*Sizewell C (SZC)*

Planning Inspectorate Reference: *EN010012*

*Deadline 6 – 6 August 2021*

East Suffolk Council comments on Deadline 5 submissions from the Applicant and other Interested Parties

Figure 1 - Section 60 & 61 Procedure (extract from BS5288-1)

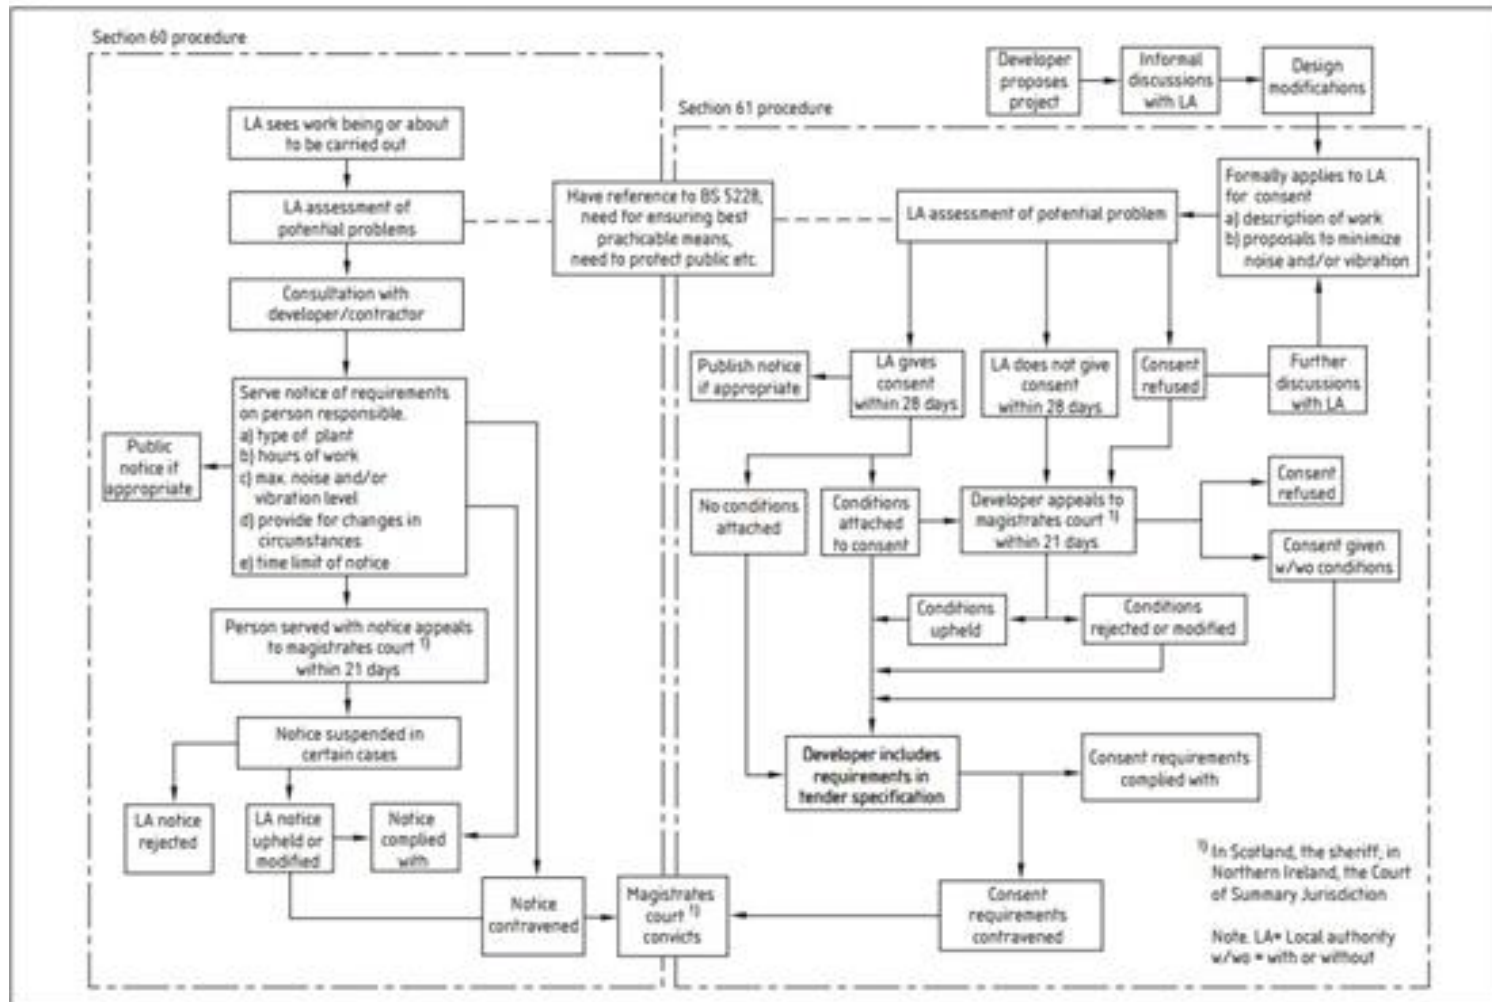
This point is made in the context of there being a clearly defined practical process for Applications for Section 61 consents and associated appeals, as summarised in Annex A of BS 5228-1.

**In order to accept the Bespoke Mitigation Plans process, ESC would need this to be substantially closer to the formal Section 61 process than is currently proposed.** This would also require legal input to ensure that the process is enforceable in practice (presumably via the CoCP and/or directly through the DCO).

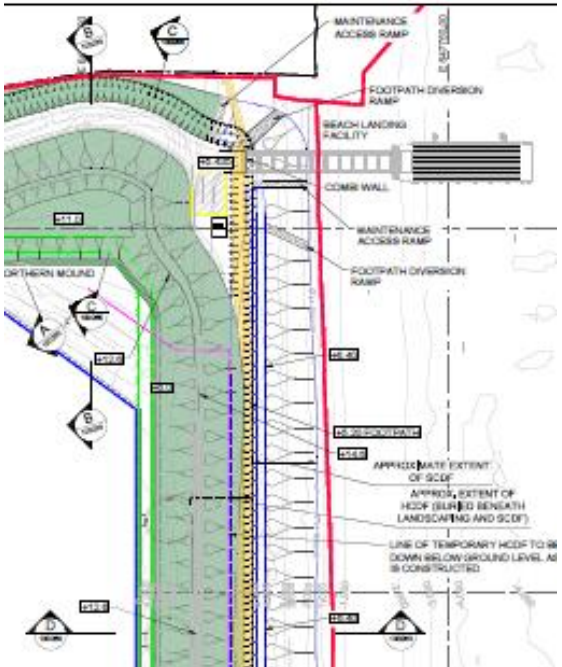
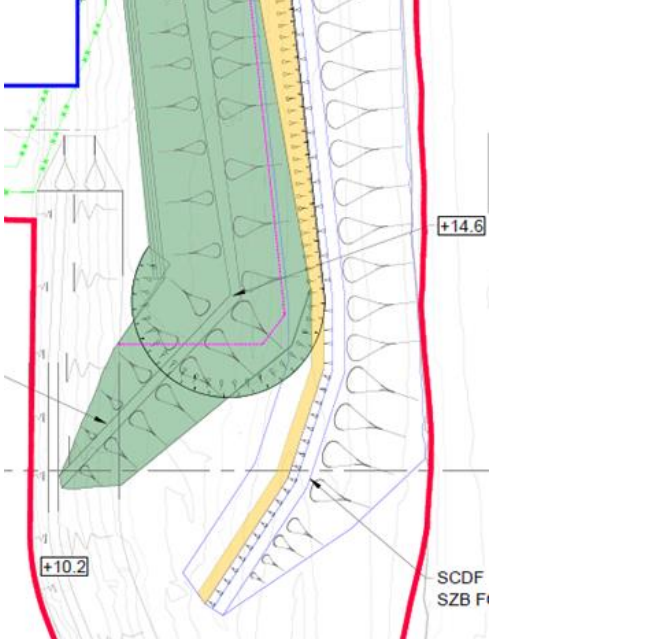
<p>MAINTENANCE ACCESS RAMP FOOTPATH DIVERSION RAMP BEACH LANDING FACILITY CONCRETE WALL MAINTENANCE ACCESS RAMP FOOTPATH DIVERSION RAMP APPROXIMATE EXTENT OF SCDF APPROX. EXTENT OF HGF (BLIND BENEATH LANDSCAPING AND SCDF) LINE OF TEMPORARY HGF TO BE DOWN BELOW GROUND LEVEL AS CONSTRUCTED</p>		<p>Identify any new monitoring and mitigation issues that these structures create and add them to the CPMMP.</p>
	<p>Text below is from ESC comment on Eng Design Report [REP3-062].</p> <p>There is no change to the design of these features. Concerns still apply here.</p> <p><i>However, the updated design drawings show additional features, refer to Figure 3-11 (below). These include:</i></p> <ol style="list-style-type: none"> <li><i>1 Maintenance access ramps: required to maintain the soft sea defence and repair the hard sea defence. <u>These will be permanent structures.</u></i></li> <li><i>2 Coast Path diversion ramps for when the Permanent BLF is used. These are intended to be a soft feature created using shingle/sand beach material and temporary in nature.</i></li> </ol>	<p>As noted in relevant text column.</p>	<p>Observation.</p>

<p><u>3 A sheet pile abutment wall that replaces the end span on the Permanent BLF. This allows the Coast Path to cross the Permanent BLF at grade.</u></p>		
<p>4</p>			<p>The narrowest part of the SCDF is now at the Sizewell B overlap.</p> <p>This will create a steeper SCDF seaward slope and increase erosion pressure here.</p>	<p>Produce sectional drawings that show the shape of the SCDF at this location.</p> <p>Use this data in calculations on SCDF viability and assessment of the impact of shoreline retreat risk on HCDF foundation levels.</p>
<p>6</p>		<p>PERMANENT COASTAL DEFENCE FEATURE TYPICAL SECTIONS (MAIN) -100263</p>	<p>What is the rationale for the design, maintenance and ultimate plight of the Landscaping layer that would be placed over the rock armour with an estimated overall thickness (including the narrow extension of the SCDF) of about 2.9m.</p> <p>The hydraulic efficiency (run up and overtopping amelioration) of rock armoured slopes depends (inter alia) upon energy dissipation with the voids of the rock matrix. Filling them with soil plus</p>	<p>Clarifications required regarding:</p> <ul style="list-style-type: none"> <li>• At what point will be the landscaping soil/vegetation be removed so that the rock revetment can perform efficiently when needed?</li> <li>• Is it the case that the hydraulic performance is premised on the basis of the landscaping being kept</li> </ul>

nearly three metres above the rock level would, on the face of it, be detrimental to performance.	<p>in place? If so, what additional height of crest is thus required (and allowed for?) to offset the lost efficiency in slope performance?</p> <ul style="list-style-type: none"> <li>Regarding the latter being affirmative, what impact would this have on footprint?</li> </ul> <p>Latter point is our main concern in respect or coastal processes.</p>
7		<i>PERMANENT COASTAL DEFENCE FEATURE ADAPTIVE DESIGN TYPICAL SECTION 100264</i>	<p>Shows Adaptive profile at D-D.</p> <p>Is an Adaptive profile proposed to be applied at Sections A, B and C and adjacent to the PBLF if triggered by SLR?</p> <p>The Eastings confirm a 5m retreat of both HCDF and Adaptive HCDF toe at section DD when compared with the previous issue (Bk2 2.5 <a href="#">[REP3-004]</a>).</p> <p>There is no information provided to allow assessment of the extent of retreat of the BLF promontory that is reported as 15m.</p>	<p>Add an illustration of the proposed Adaptive profile over sections A, B and C and over the PBLF frontage.</p>

**Figure 1 – Extract from the Noise and Vibration Baseline Report showing PRS1**

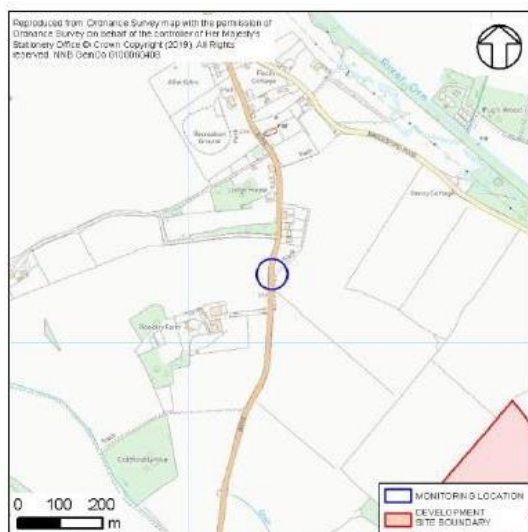
Position PRS1 is intended to represent the nearest residential receptors in Hacheston village. However, the Noise and Vibration Baseline Report (Bk6, Vol2, Ch11) shows that this position only 1-2m from the edge of the B1116 carriageway. This is a relatively busy road linking the A12 with Framlingham and is also just outside the 30mph zone so southbound vehicles are typically accelerating away from Hacheston at this spot.

However, by comparison the nearest receptors are set back at least 18-20m from the road. Not only this but it will be the south/east façades of these dwellings which are facing and most exposed to noise from the park and ride site, and these façades would be at least partly screened from road noise. For these reasons we consider it unlikely that this monitoring position is representative of the nearest receptors in Hacheston.

**Figure 2 – Extract from the Noise and Vibration Baseline Report showing RT14**

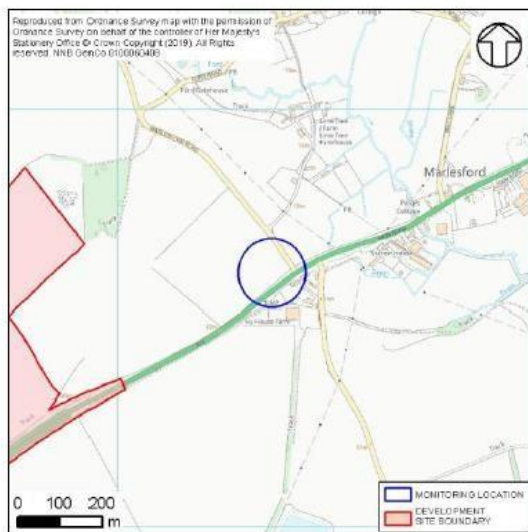
Position RT14 (and by extension Noise Receptor Location C) are apparently intended to represent the nearest residential receptors in the village of Marlesford. However, this monitoring position is directly adjacent to the A12 and there are relatively few dwellings there in comparison to the main settlement of Marlesford. The main village of Marlesford is situated approximately 550m to the north, and ambient noise levels in the village are likely to be significantly lower than at Position RT 14 due to the

increased distance and other environmental effects (ground absorption, landscape screening).

**Figure 3 – Aerial photo showing distance from RT14 to main settlement of Marlesford**

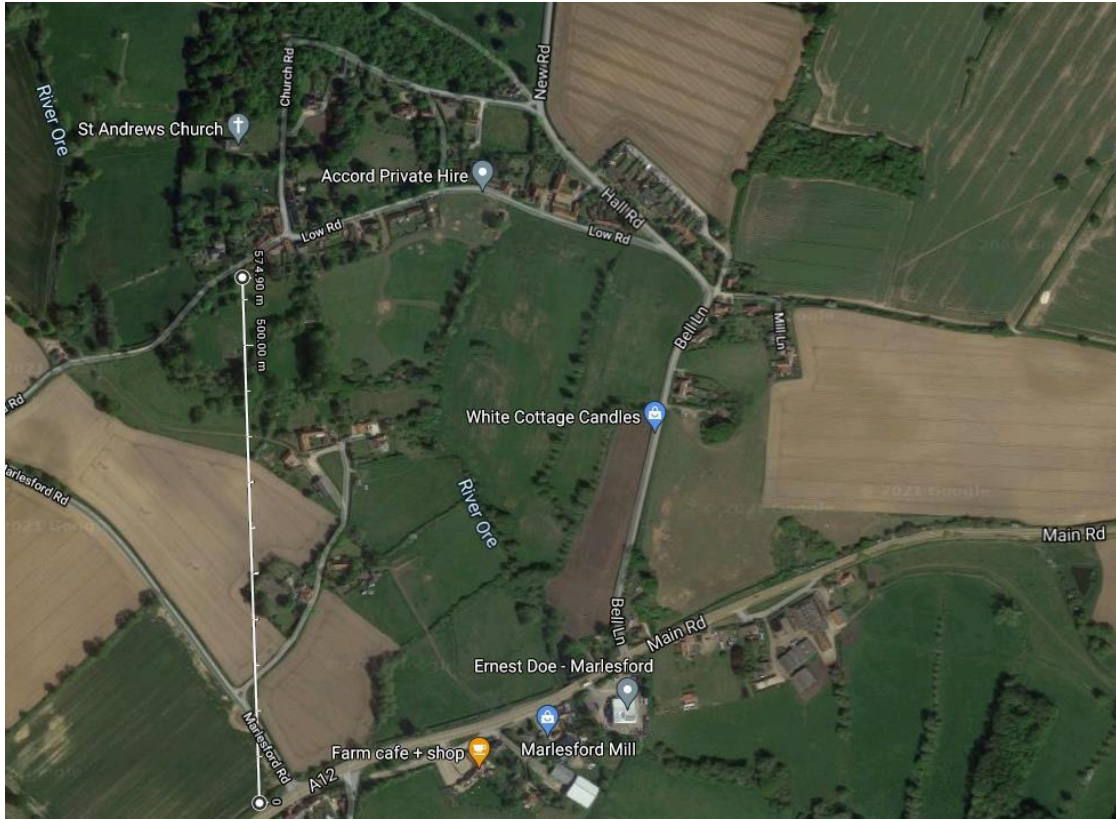
For these reasons we consider it unlikely that this monitoring position is representative of the nearest receptors in the main settlement of Marlesford.

**Figure 4 – Figure 4.1 from Bk6, Vol4, Ch4 showing Receptor C and Marlesford (circled)**

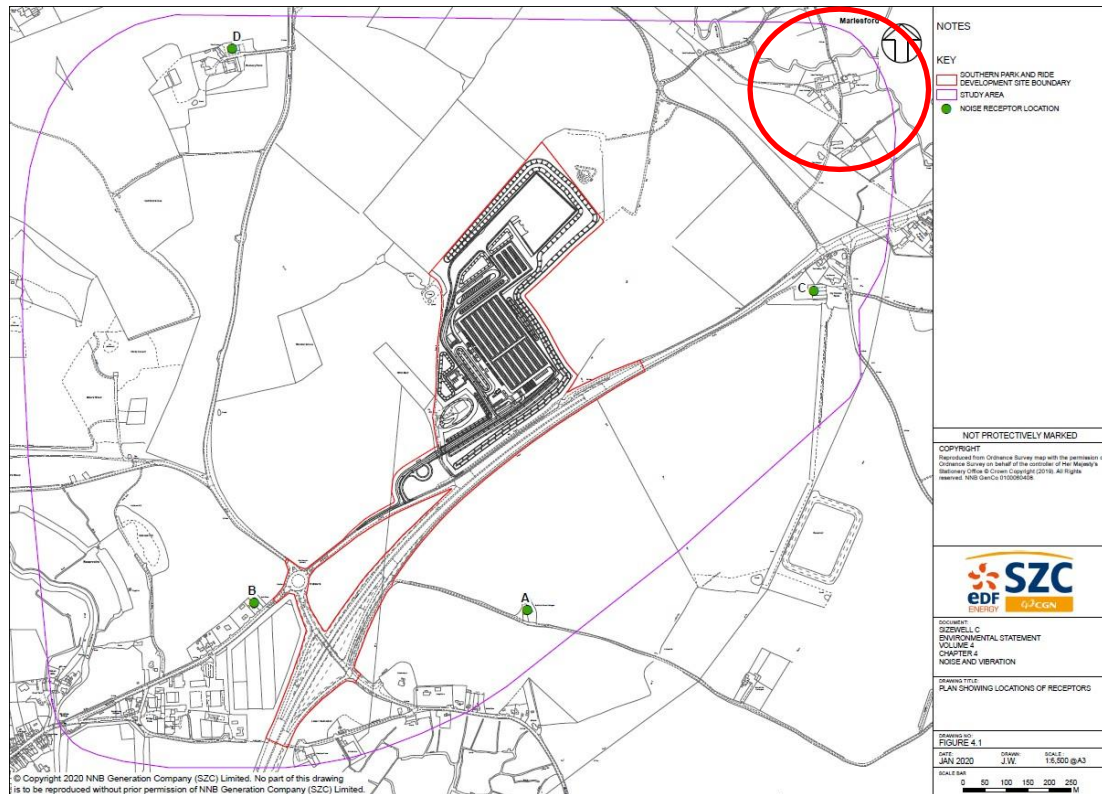
28. Receptor C at the Southern Park Ride Site is apparently intended to represent the village of Marlesford. However, as shown in Figure 3 this receptor location (and the associated baseline monitoring position RT14) is relatively close to the A12 and the main settlement of Marlesford is actually situated more than 500m away to the north.

Receptor C does not represent the nearest receptor in Marlesford.

The nearest residential property to the east would be Ford Gatehouse, Ford Road, as circled in red in Figure 5. This property is closer to the east site boundary than any properties in the vicinity of 'Receptor C' and ambient noise levels on Ford Road will be much lower than adjacent to the A12 (so will require additional baseline measurements per RFI 28). ESC therefore request that The Applicant provides an updated assessment which includes Ford Gatehouse on Ford Road to the east, circled in red.
